Preparation Support for Lelystad Airport Consultation

Report for LVNL

Document title	Preparation Support for Lelystad Airport Consultation Report for LVNL
Author	Helios
Produced by	Helios 29 Hercules Way Aerospace Boulevard - AeroPark Farnborough Hampshire GU14 6UU
Produced for	LVNL
Helios contact	Alan Corner Tel: +44 1252 451 651 Fax: +44 1252 451 652 Email: Alan.Corner@askhelios.com
Version	V1.0
Date of release	06 September 2017
Document reference	P2386D009

Figure 1: Route concept A connecting routes (NM TMA A available)

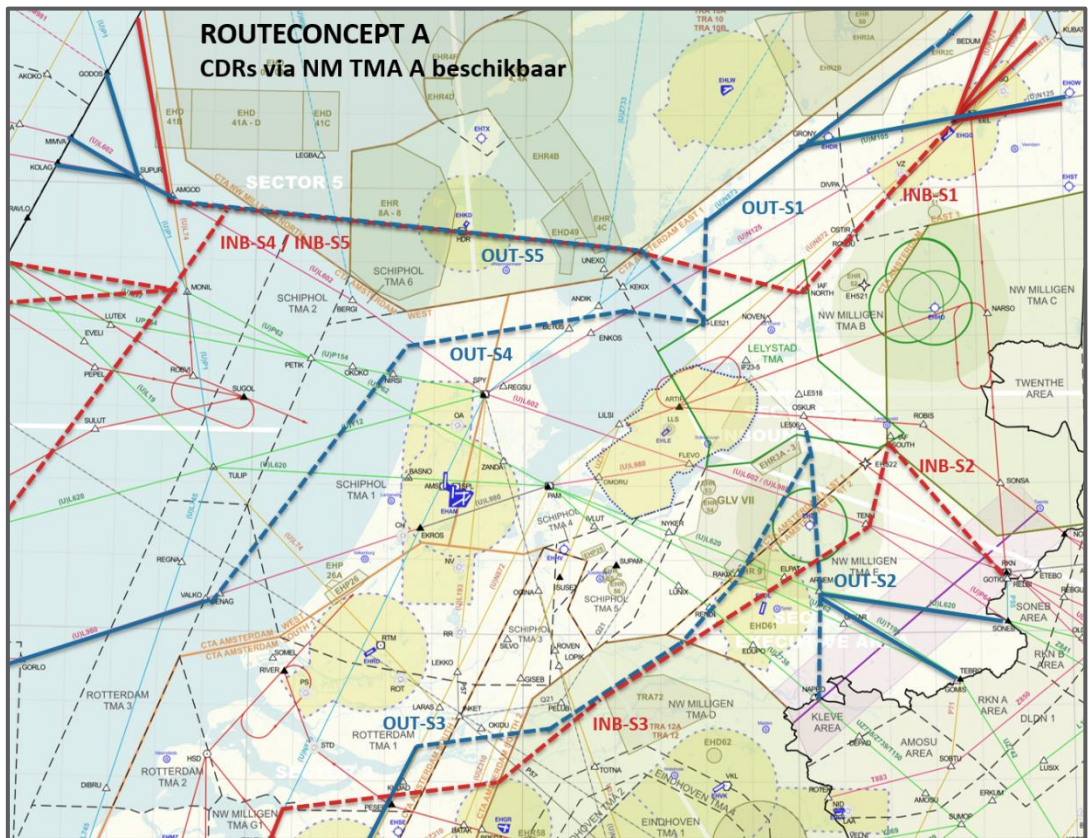
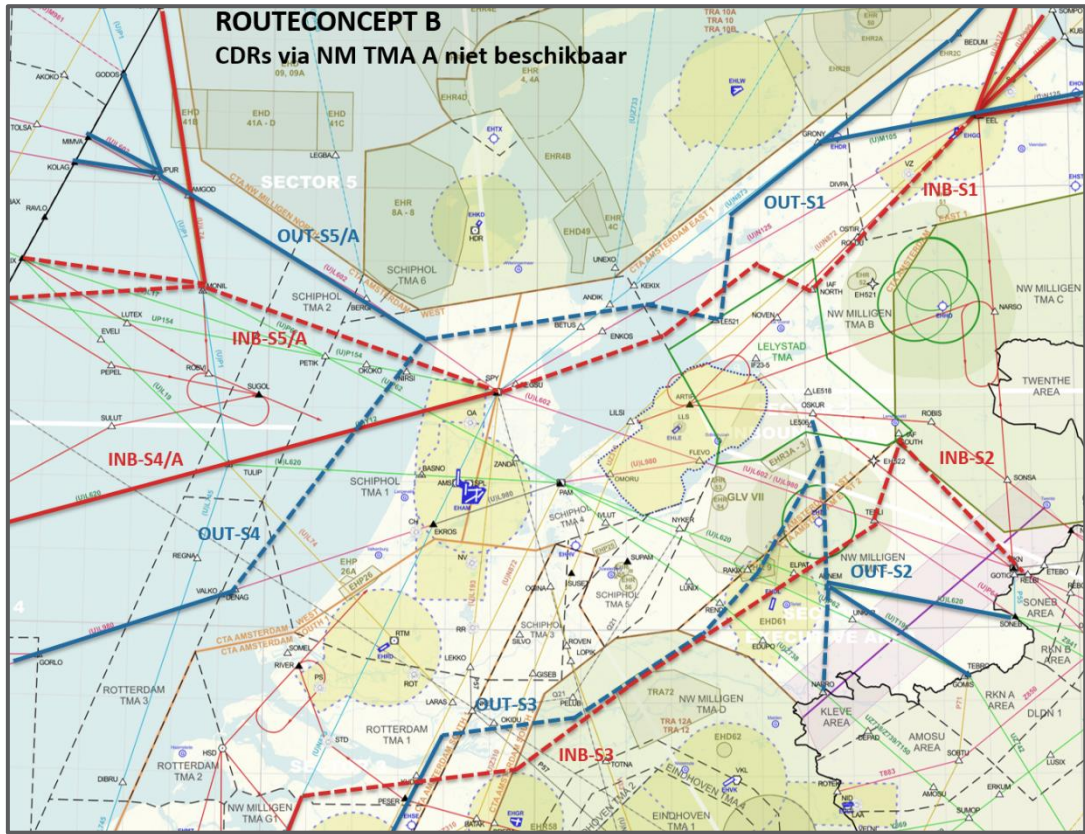
We have reviewed the outcomes of the RTS and analysis to determine the suitability of the down-selected routes.

Overall and in our opinion, the proposed route-set will enable the start of operations at Lelystad in 2019.

In terms of the down-selected routes, we are content that within the constraints of the existing airspace and the 'given' design of the Lelystad airport arrival and departure routes (Conops B+), the selected routes appear to be the most suitable from those proposed by LVNL and CLSK to enable the start of operations at Lelystad in 2019 whilst having least impact on Schiphol and military air traffic operations. However, there remain consequences for other airspace users which the design of procedures has not, as yet, fully resolved.

The addition of a CDR through the EHR-8/ EHD49/TRA10 region is a sensible alternative to reduce impact on the Schiphol airport TMA whenever possible, and correlates well with developing FUA (Flexible Use of Airspace) in the Netherlands; provided the necessary Airspace Management processes are enabled.

Figure 6: Lelystad Airport TMA

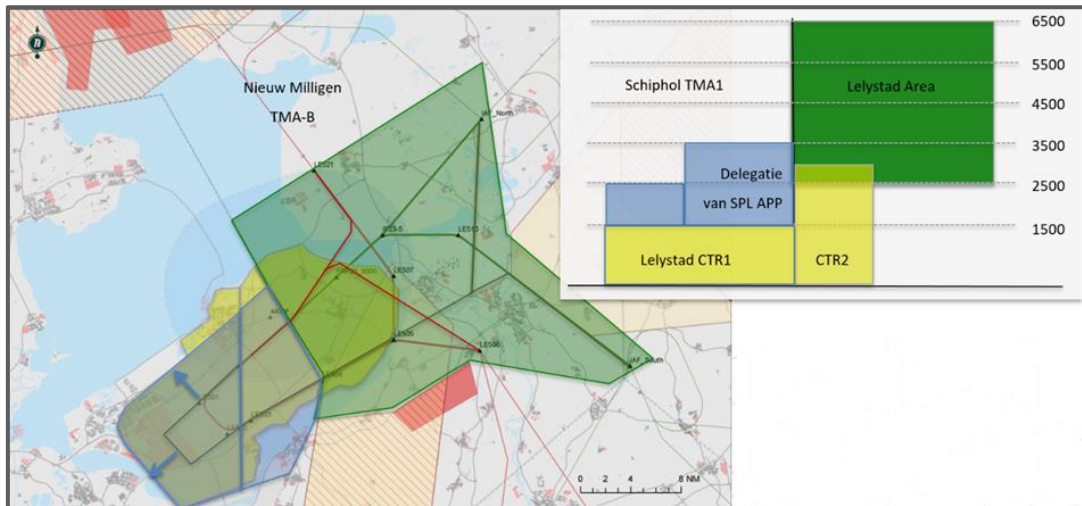
Evidently, the Lelystad airport TMA design appears to show adequate lateral containment of the Conops B+ arrival and departure routes.

Figure 7: Vertical profiles of the arrival (green) and departure procedures (red) for Runway 05

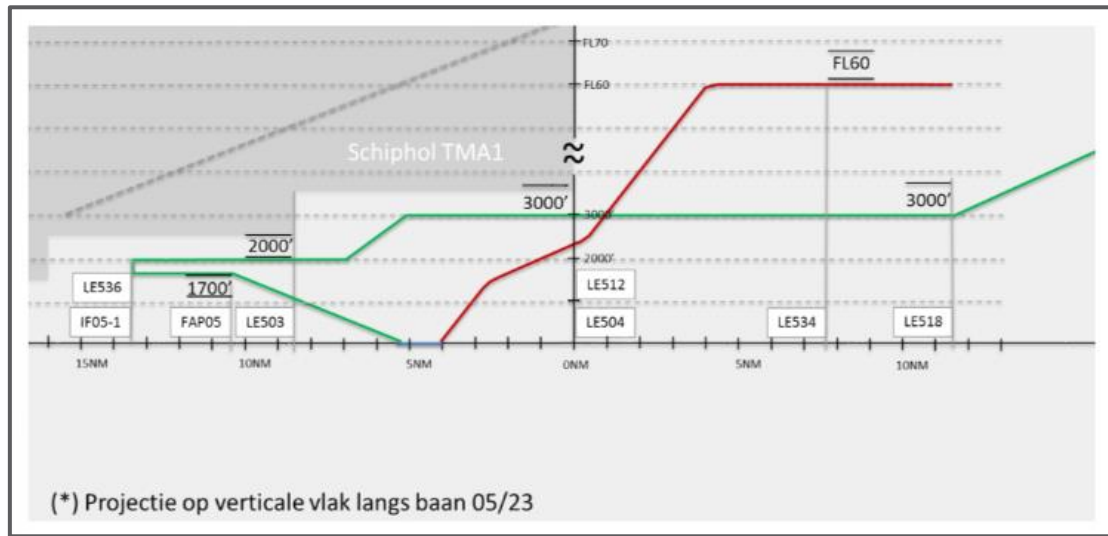
The departure procedures are shown climbing from threshold elevation to FL060 (approx. 6000ft) over a distance of approximately 11.5 NM (to waypoint LE534); this equates to a PDG of circa 8.5%. Whereas, the arrival procedure involves a series of shallow stepped descents culminating in a final uninterrupted descent from an altitude of 1700ft to threshold over a distance of approximately 6 miles; this equates to a descent gradient of circa 5.2% (3 degrees). All conceptual design gradients therefore fall within PANS OPS criteria.

Figure 8: Vertical profiles of the arrival (green) and departure procedures (red) for Runway 23

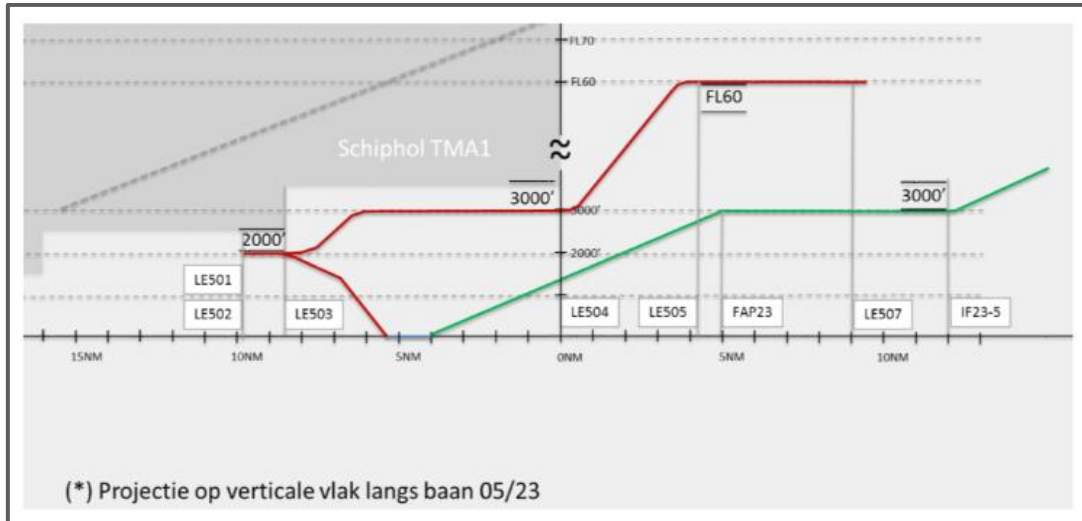
The departure procedures are shown with a series of interrupted climbing segments in order to keep departing aircraft within the stepped vertical limits of the TMA. The steepest portion involves a climb from altitude 3000ft to 6000ft over a distance of approximately 5 NM; this equates to a PDG of circa 9.9%. Whereas, the arrival procedure involves a series of shallow stepped descents culminating in a final uninterrupted descent from an altitude of 3000ft to threshold over a distance of approximately 8 NM; this equates to a descent gradient of circa 5.2% (3 degrees). All conceptual design gradients fall within PANS OPS criteria.

Figure 9: Vertical cross section of Lelystad TMA

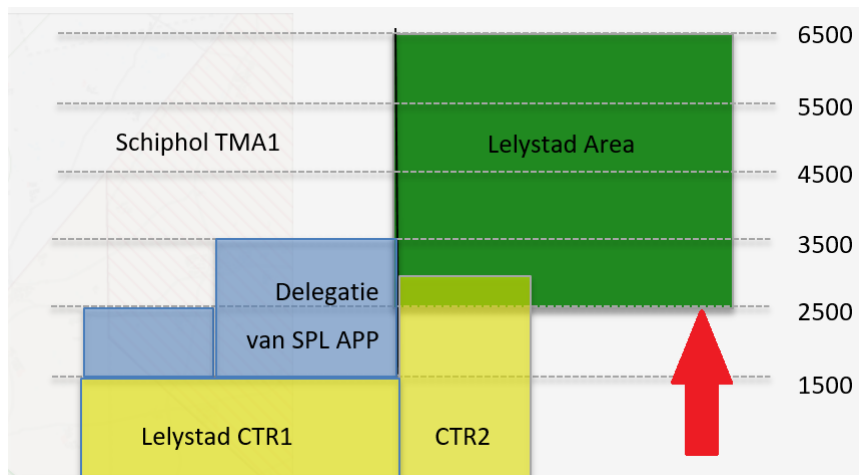
We note that whilst the Lelystad TMA achieves vertical containment of the Conops B+ routes, the base level of the Lelystad airport TMA in the vicinity of the Initial Approach Fixes at 2,500ft (as shown below in Figure 9) seems unnecessarily low, when the stated requirement is for inbounds to maintain a minimum of FL060 and to descend to 3,000ft 'as late as possible'.
